WEBER FIRE DISTRICT
Fire Marshal, Ted Black
Site Plan Review

SITE PLAN
PARCEL # 10-041-0004
DEVELOPER: STEPHANIE LOUD

BUSINESS SITE PLAN
LOCATION: WEBER COUNTY
ADDRESS: 9565 W. 900 S.

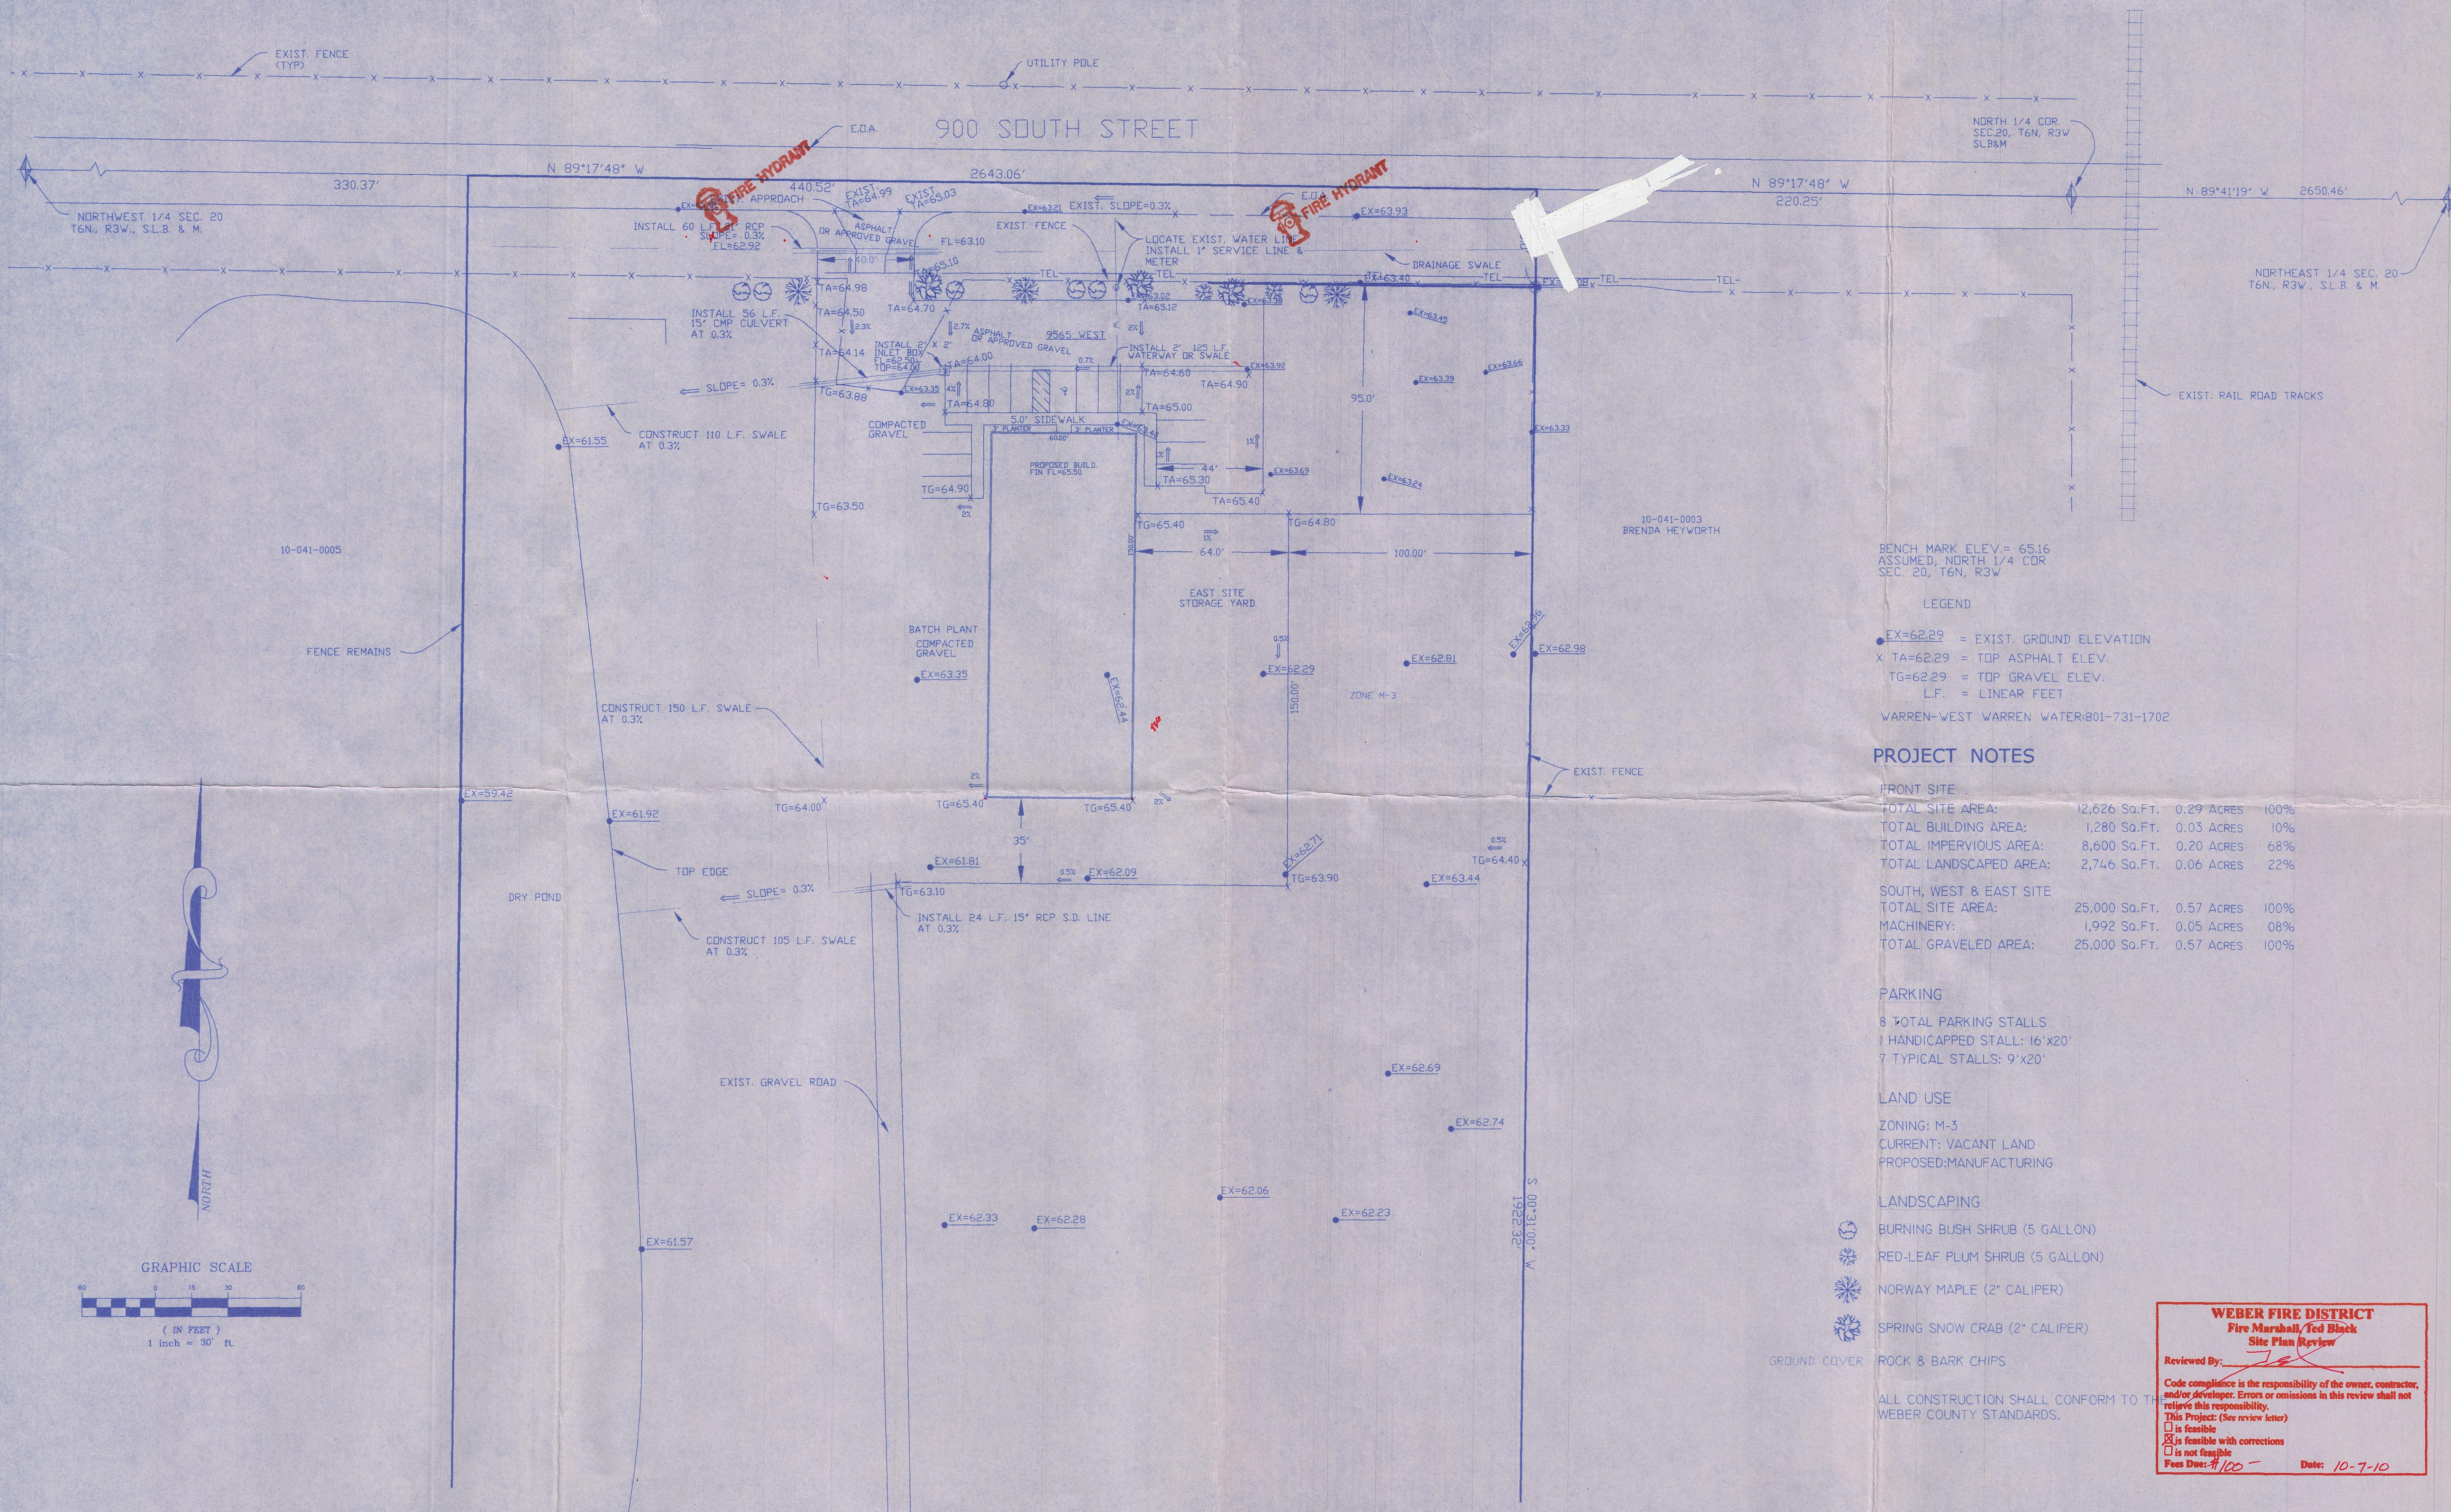
This Project: (See review letter)

☐ is feasible
☒ is feasible with corrections
☐ is not feasible
